**Intercounty Connector  
Mandatory Referral No. 06809-SHA-1  
Status Report #17**

**Prepared 1/16/09 for the 1/29/09 Roundtable Discussion**

**SUBJECT:** ICC Status Report #17: Special Protection Area (SPA) Activities

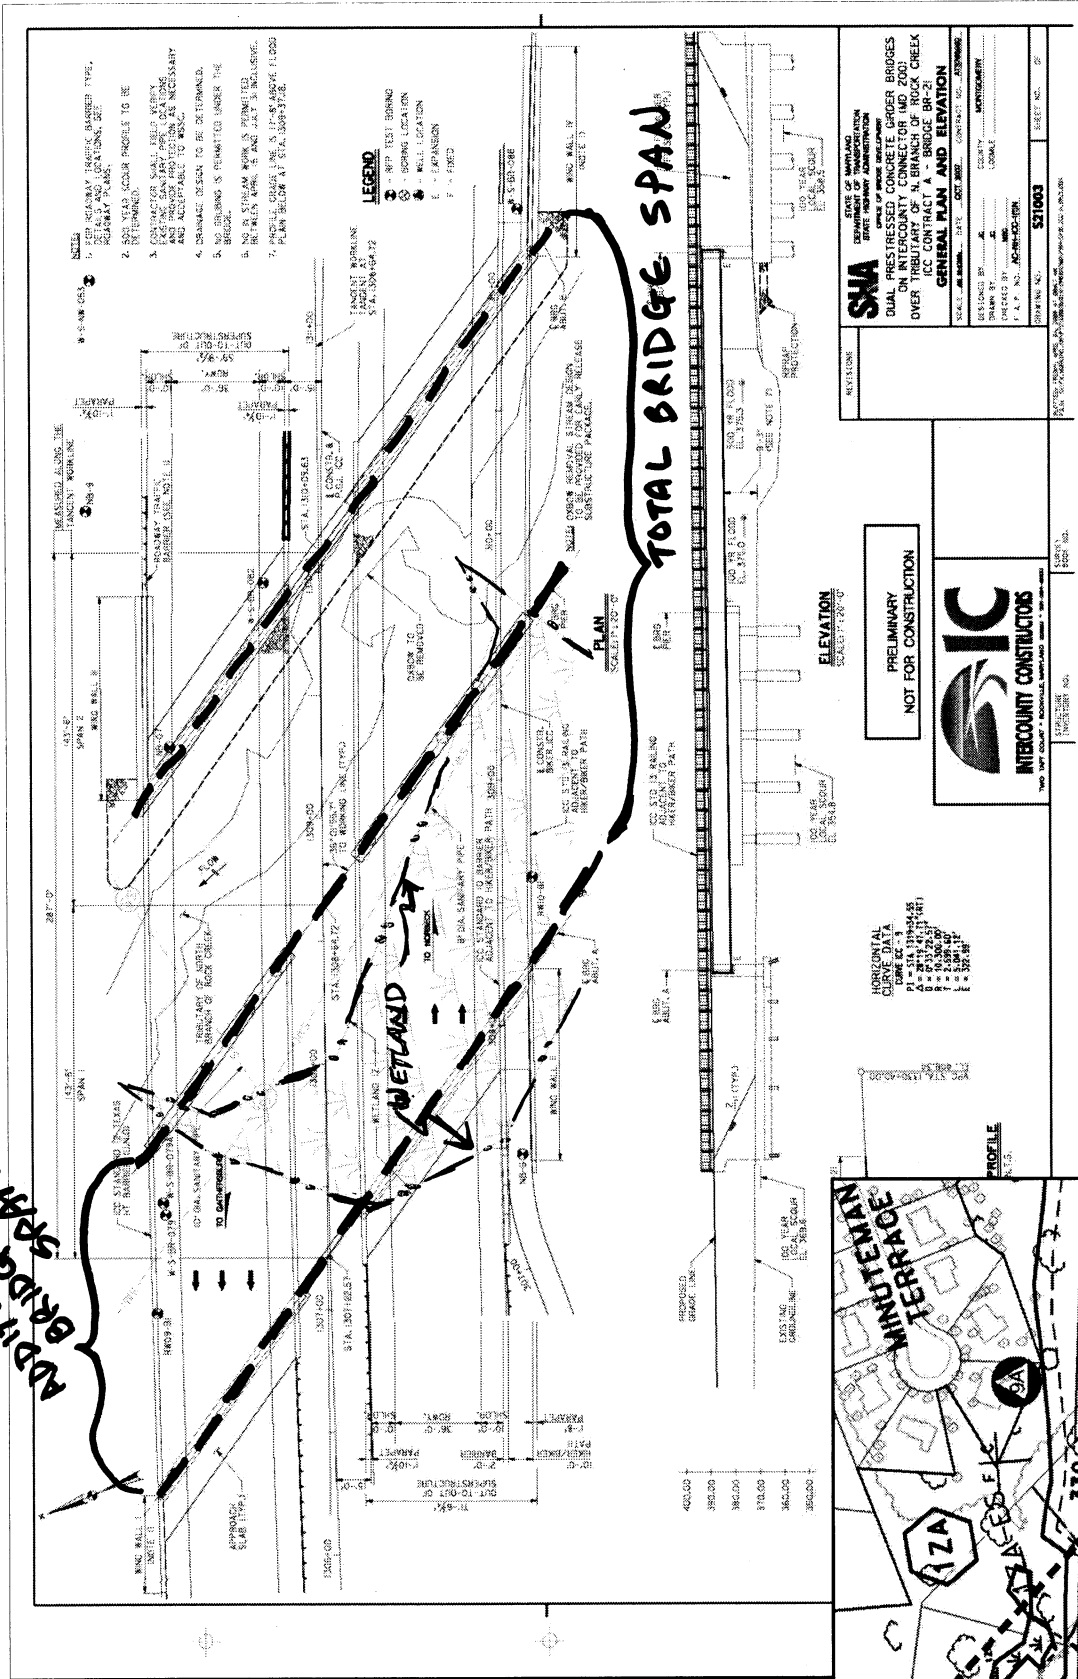
- Thus far the designer has presented no method of testing these facilities after they are constructed in order to verify that the design elements were achieved. Without such a method there is no way to know whether the theoretical design goals were met.

- Ultimately it will be up to MDE to approve whatever is designed for this project. The role of DPS is advisory and is limited to determining whether in our opinion the proposed stormwater management scheme is generally consistent with typical Special Protection Area criteria. If MDE approves these designs as they are currently presented then by nature of that approval it must be said that channel protection is "provided" and that aspect of the stormwater design has been

successfully accomplished. DPS does not have authority to require any design modifications and we can not approve or disapprove any of the design elements. We hope our concerns with respect to the feasibility of these experimental designs is being communicated clearly to MDE for their consideration.

- DPS strongly advises against consideration of this type of facility design for the Upper Paint Branch SPA portion of the project. Thus far we have not seen any designs, conceptual or otherwise, for that area.

**SMA**  
STATE OF MARYLAND  
STATE HIGHWAY ADMINISTRATION  
DIVISION OF BRIDGE DEVELOPMENT  
GENERAL CONTRACTOR - BRIDGE BR-21  
GENERAL PLAN AND ELEVATION

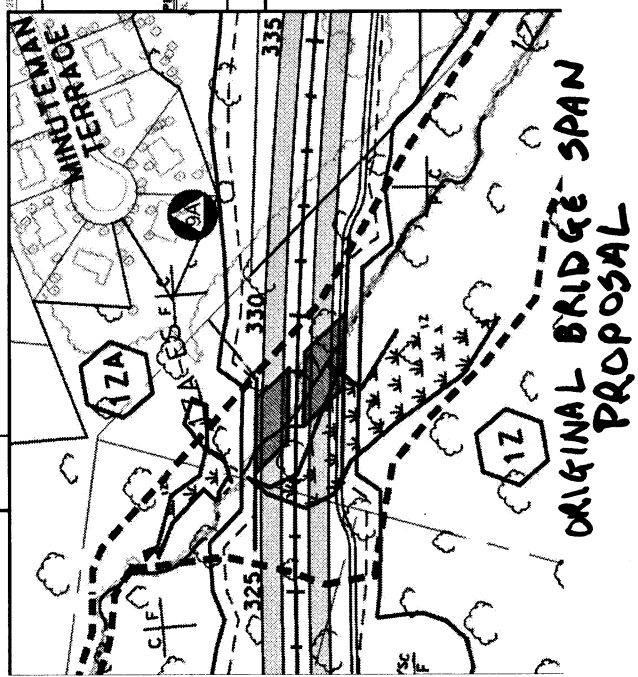
7. Feb. 2008 comment: *Staff has pursued lengthening the proposed bridge (Bridge #21) over the tributary of North Branch to avoid filling the wetland. However, the Federal and State permits and Table IV-68 in the Final Environmental Impact Statement set the designed bridge length as sufficient to protect the resource. If SPA requirements were fully applied, the bridge should be lengthened to avoid filling of 0.5 acre of a 1.1-acre forested wetland in the North Branch stream valley, consistent with the intent of Commitments #20 and #54 in the ROD.*
